Application Number:	2025/0318	Application Type:	Full Planning Permission
Proposal:	Erection of 11 dwellings with associated parking, landscaping and infrastructure, including the creation of a new vehicular access from Booth Road.	Location:	Heath Hill Booth Road Stacksteads Bacup Lancashire OL13 0SF
Report of:	Head of Planning and Building Control	Status:	For publication
Report to:	Development Control Committee	Date:	06.10.2026
Applicant:	Brother Developments Ltd	Determination Expiry Date:	09.10.2026 (Time extension agreed)
Agent	Mr Daniel Connolly – Connollys

1. RECOMMENDATION

Approval subject to the conditions contained within this report.

PLOT 05 & 06

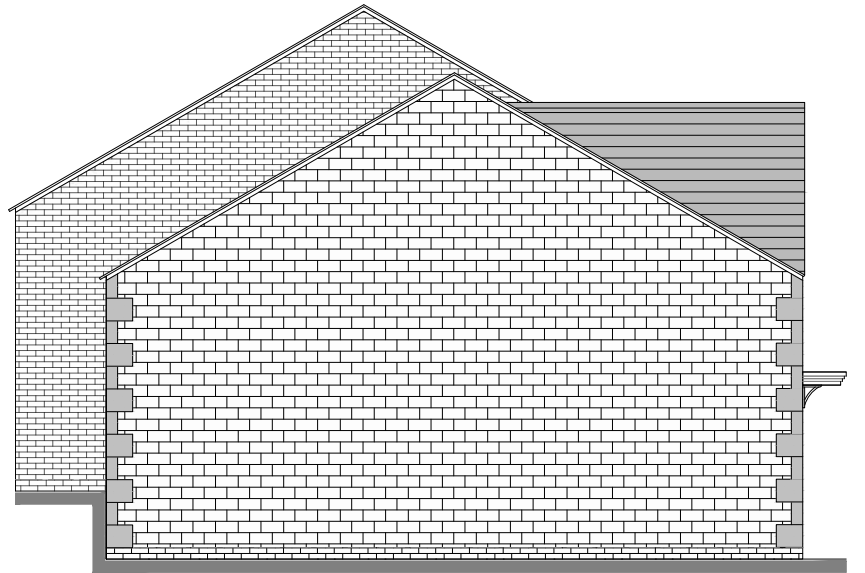
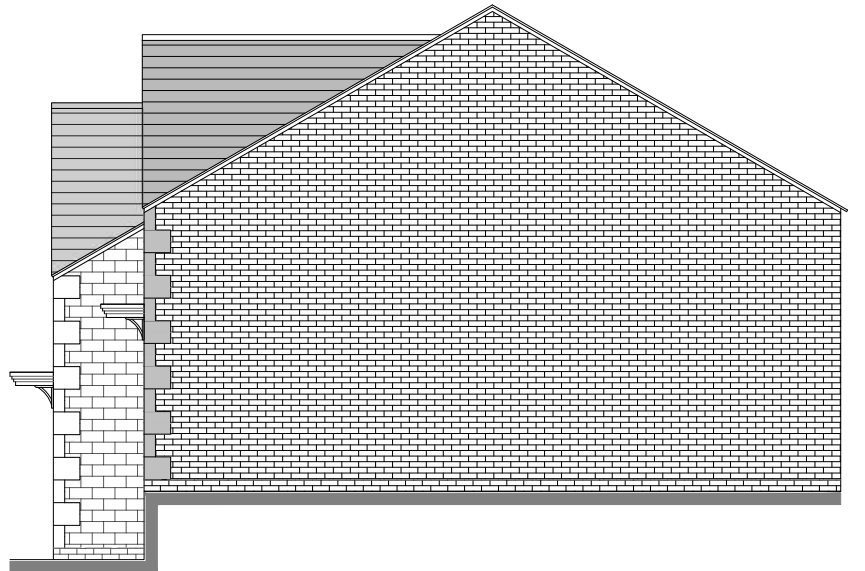
Figure 1: Example of originally proposed roof lines (Plot 5 & 6 shown)

It is understood that the roof line had been designed in order to address the constraints of the site in relation to the proximity of neighbouring dwellings. These roof styles were however considered to appear odd and detracted from the design of the dwellings. The applicant was asked to provide examples of development where similar roof styles had been used within the Borough however no examples were submitted.

Following discussions between the case officer, the applicant and the applicant's agent amended plans have been submitted. These now show that visually prominent elevations of the dwellings will now contain natural stone with the dwellings positioned centrally within the site being constructed from red brick. It is noted that red brick is a material used within the vicinity of the site including to the side and rear elevations of dwellings located on Booth Road and on Glenborough Avenue. The visually prominent elevations are considered to be those which are visible from both Booth Road and also from the PROW located to the rear of the site. The use of artificial stone has been removed from the proposal in its entirety. The roofing material for Plot 11 has also been updated with this now proposed to contain a natural slate roof. This dwelling is proposed to be positioned directly adjacent to Booth Road. An updated Materials Plan (drawing 2341BEB/BRSB-MA01 Rev C) shows the elevations to be constructed from natural stone and those from red brick. In addition to the above, amended house type drawings have been submitted to remove the extended roof pitches for all house types with conventional pitched roofs now proposed. An example of the amended roof style is shown below:

Figure 2: Example of amended roof lines (Plots 5 & 6 shown)

The amended materials palette and alterations to the roof design of the dwellings are considered to result in significant improvements to the scheme. The proposed materials will now appear in keeping with those in place within the surrounding area with particular emphasis on visually prominent viewpoints. A condition has been added requiring samples of the proposed external materials to be used to be submitted and approved by the Council prior to commencement of development.
